**Proposal for draft amendments to document TRANS/WP.29/GRSG/2005/8
(Regulation No. 107)**

A. PROPOSAL

"7.6.11.1 Each emergency exit shall be marked, inside and outside the vehicle, by the following symbol. An additional symbol (e.g. arrow), indicating where to find the emergency exit, may be added.

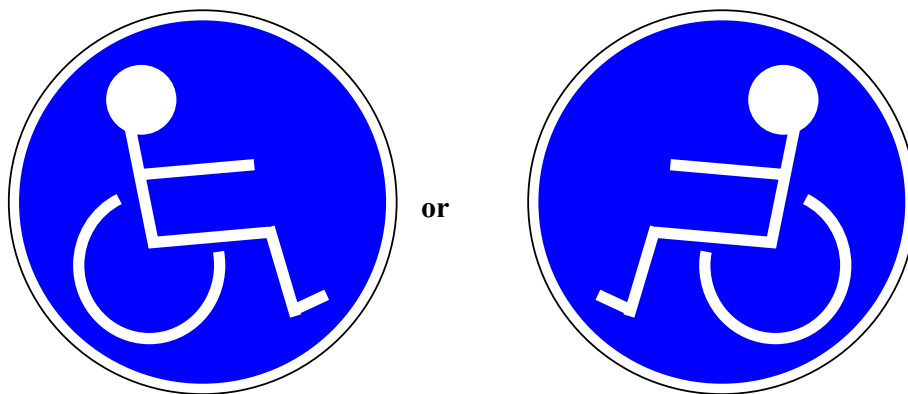
Annex 3, Paragraph 7.6.11.1., amend to read:

Colour: green basis with white symbols
Size: at least 130 mm wide and 50 mm high

Reference for safety symbols: ISO 7010 :2003 (E)
Reference for the design principles of safety symbols: ISO 3864-1:2002(E)"
